# **PUBLIC IMPROVEMENT REQUEST FOR PROPOSAL**

**RFP# 23-22**

## **PONTIAC, SWIFT, MOORE AND WRIGHT WATERMAIN AND RESURFACING PROJECT**

City of Ann Arbor  
Public Services / Engineering Unit

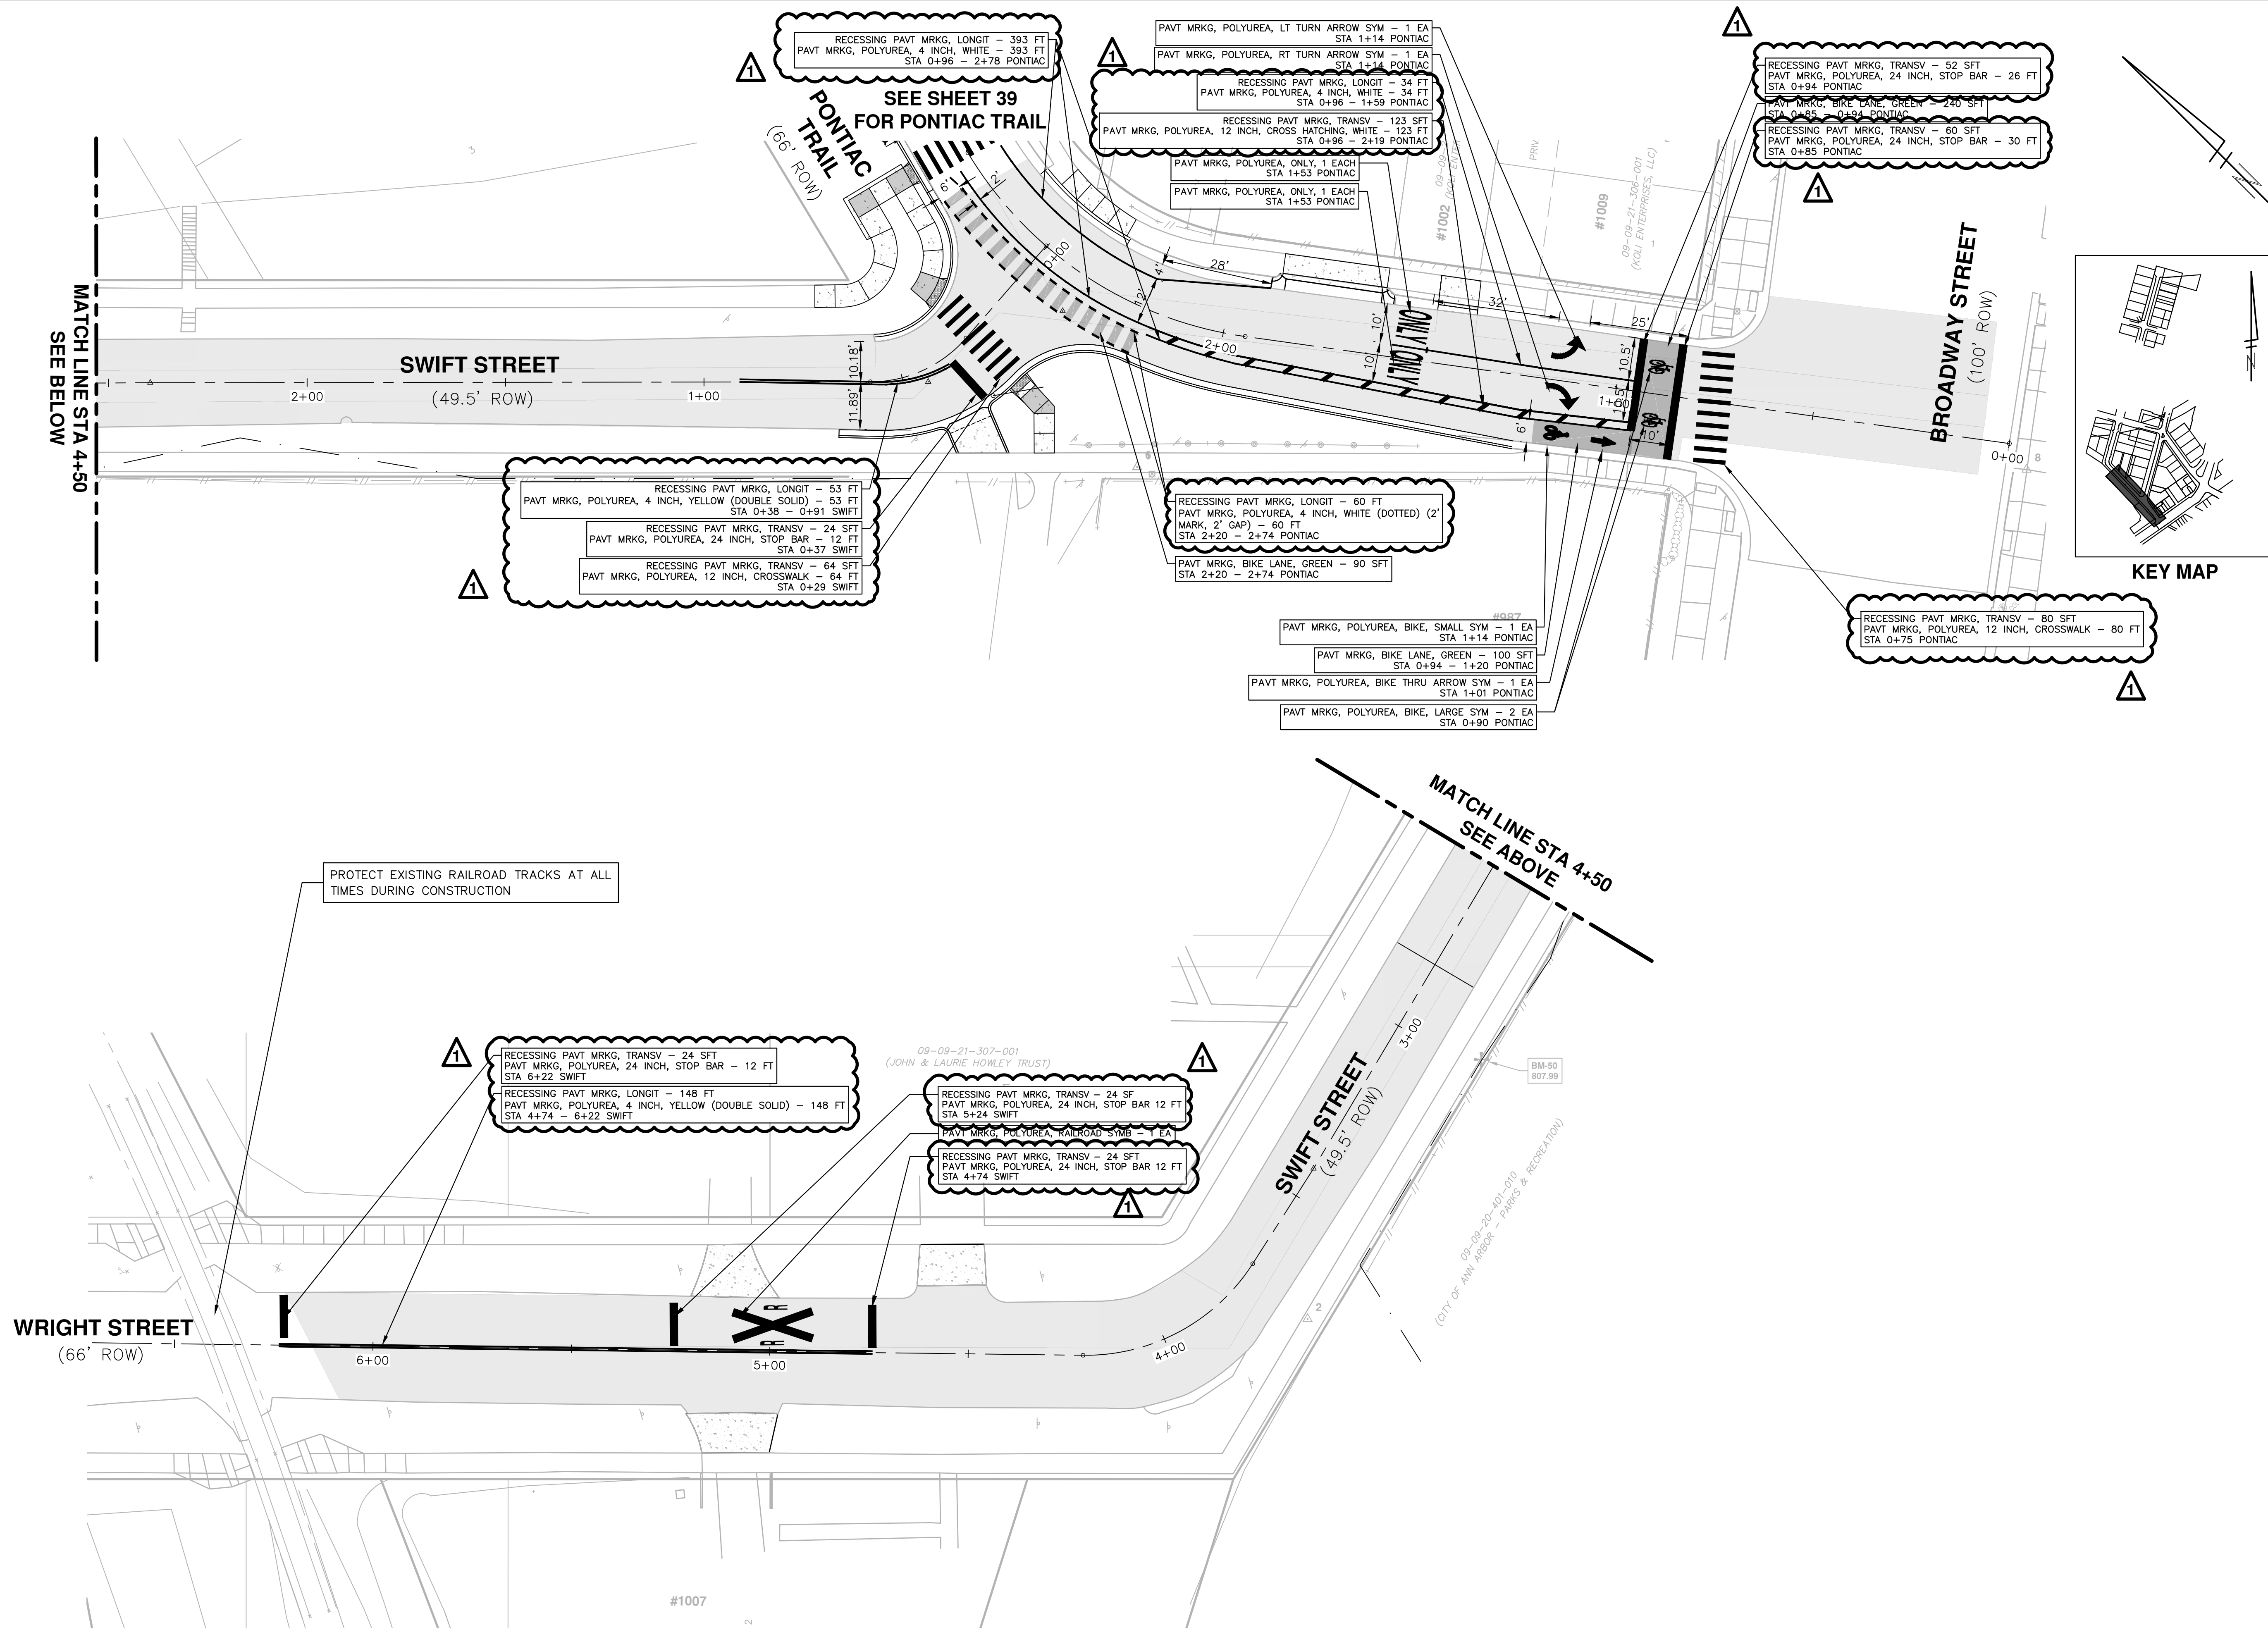
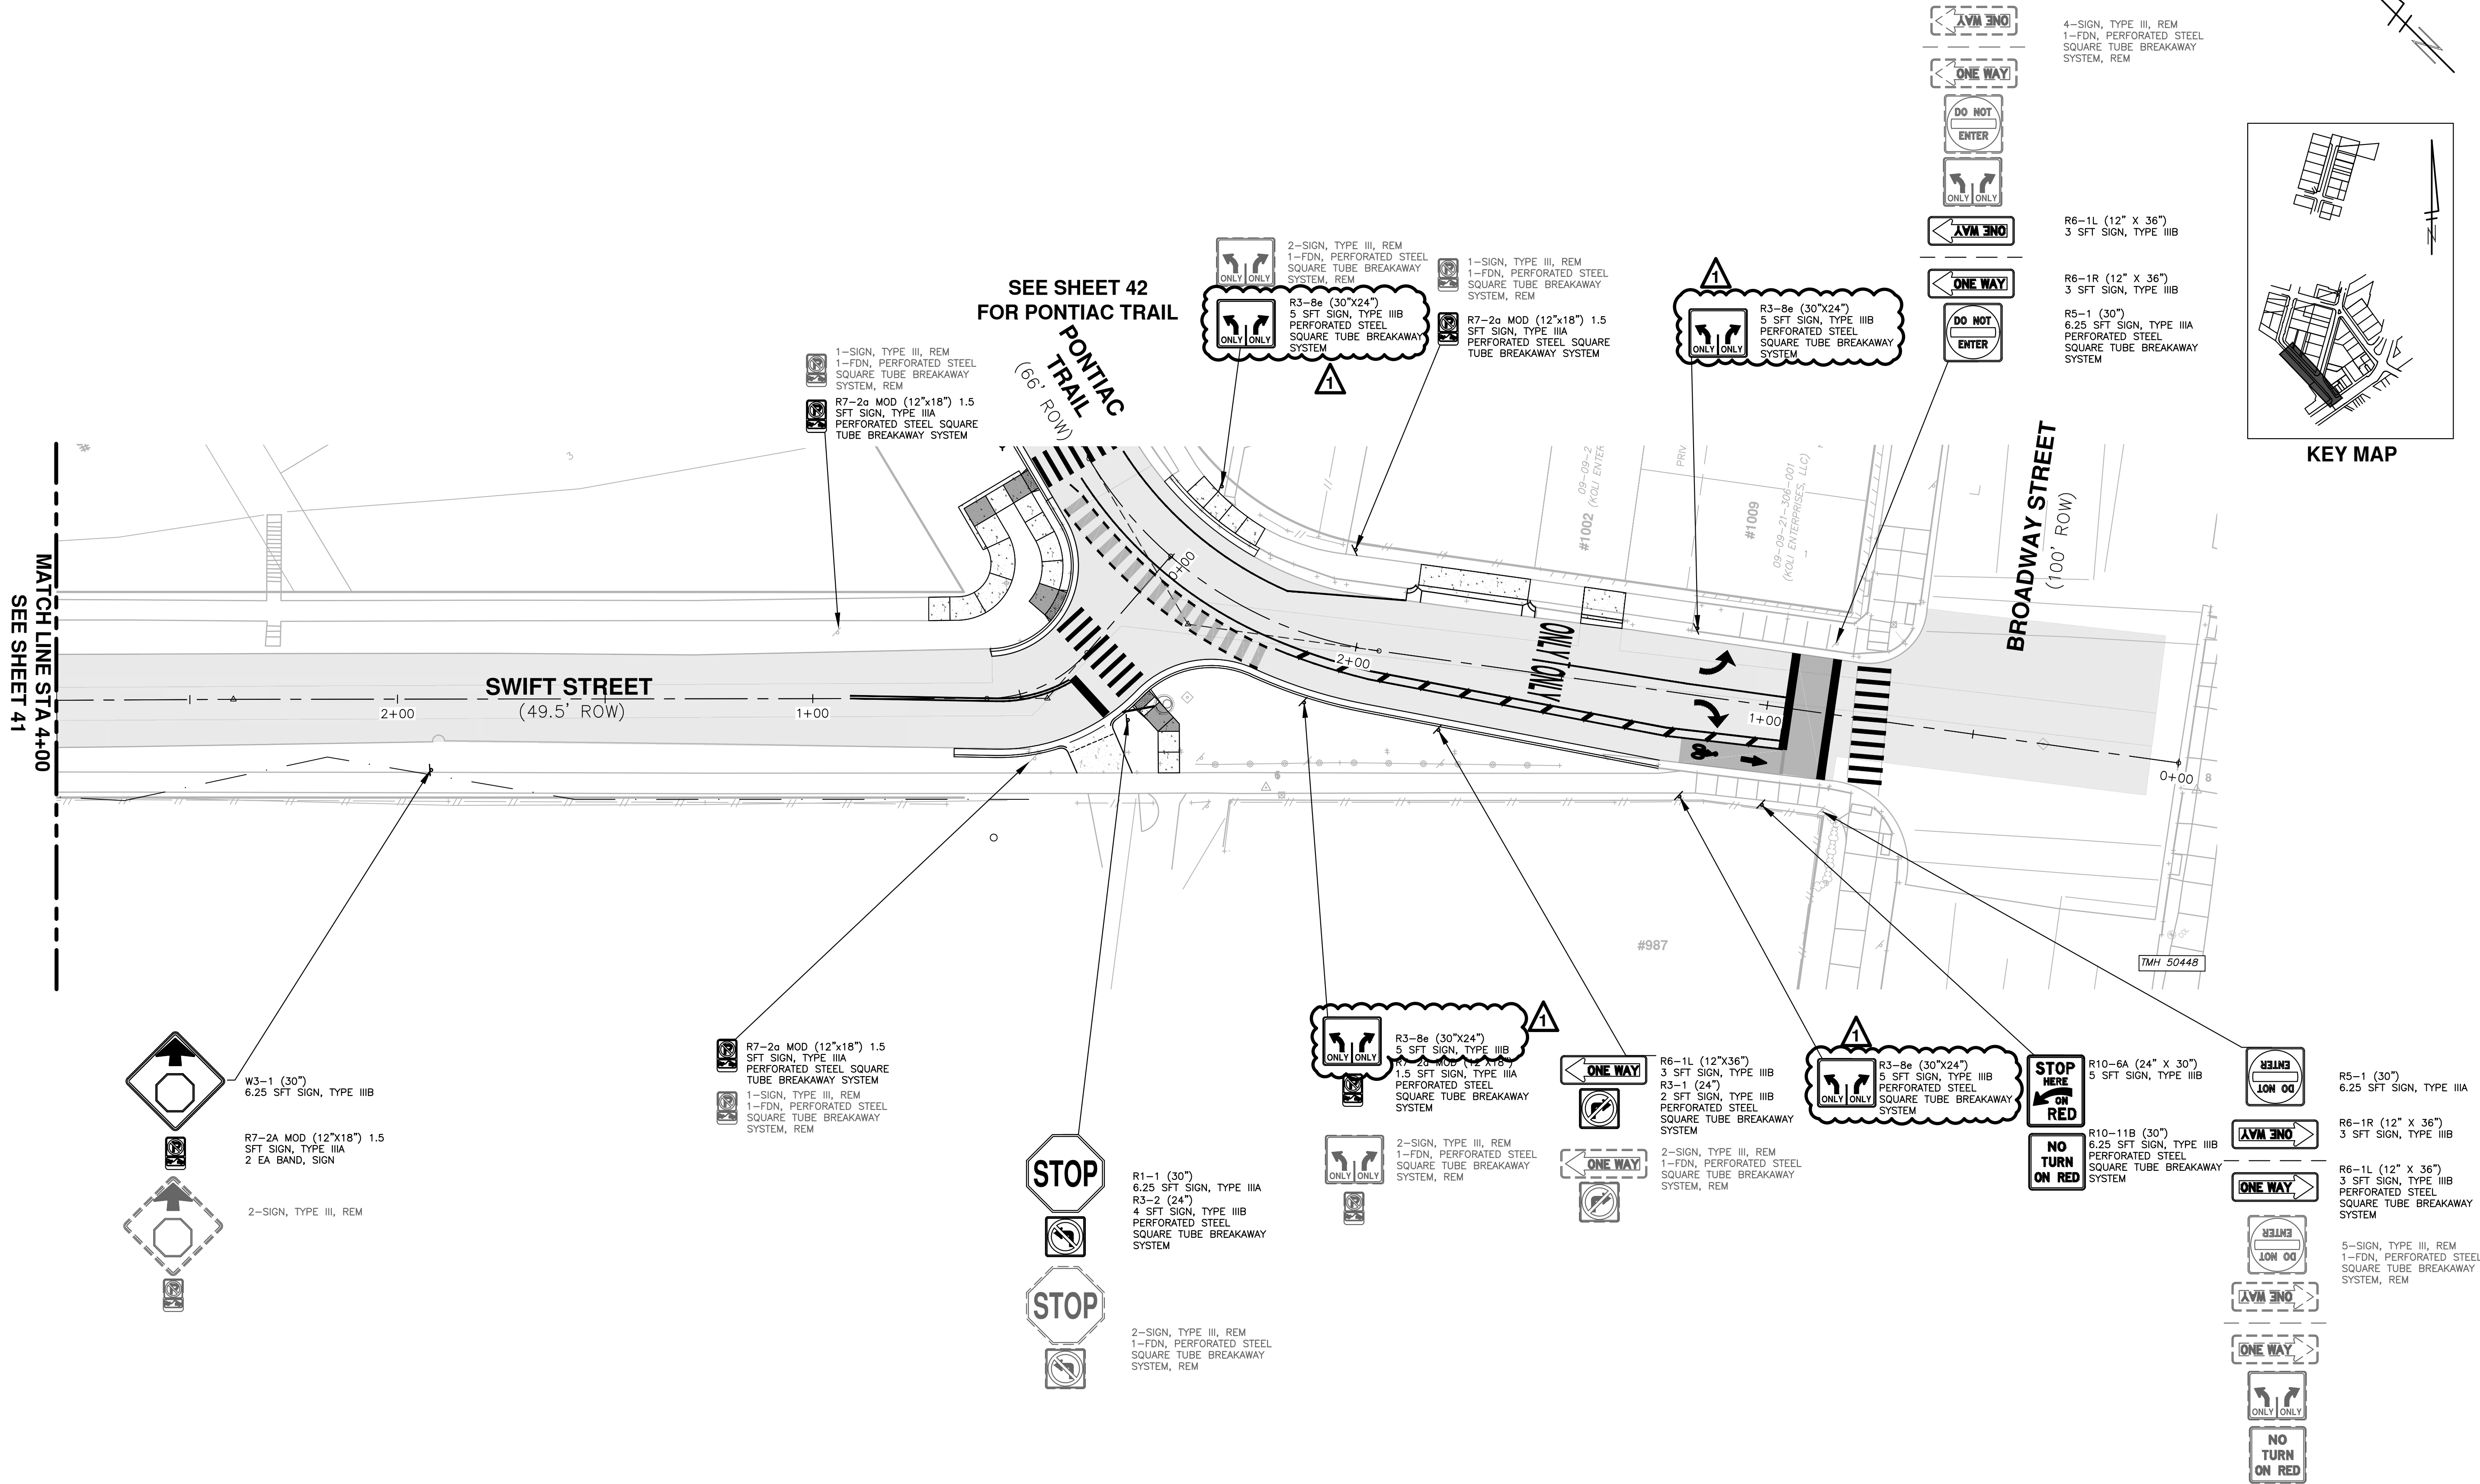
Section/Page(s)	Change
Page DS-232 to DS-235	Temporary Water Main, Wright Street: Updated to state water service connection preference, increase depth of cover requirement an other minor items.
Plan Sheets 38-42	Pavement marking plan updates include: <ul style="list-style-type: none"><li>• Minor revisions to pay item language (transv vs. longit)</li><li>• Correction to naming convention (recessing vs. recess)</li><li>• Removal of railroad crossing symbol on Moore Street</li><li>• Minor signing changes</li></ul>
Page E1-E4	The bid form has been amended to reflect the modifications of this Addendum No. 1 and other quantity corrections from original contract documents.
